Access Compliance Report

Public Rights-of-Way

| Intersection ID: 10036644 | Main Street: S_ALEXANDER_ST | Cross Street: N/A | Location: NW |
| ADA ID: 7478E4C421B2 | Ramp Type: PerpDiag | Initial Pass/Fail: Fail | Overall Compliance: No |

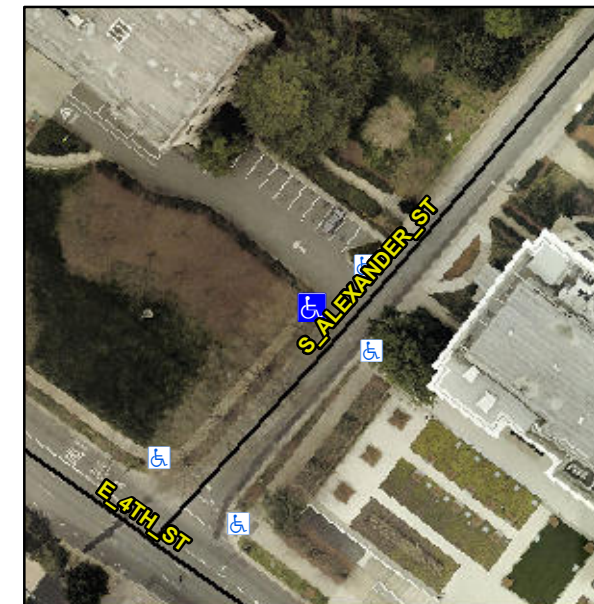
Not Found, R304.5.1, R304.5.3

| Compliance | Description | Data | Compliance | Description | Data |
|------------|-----------------------|-------|------------|-----------------------------|-------|
| No | Ramp Width (in) | 46.0 | No | Ramp XSlope (%) | 6.2 |

Remove & Replace Curb Ramp With Two New Directional Ramps or Equivalent.
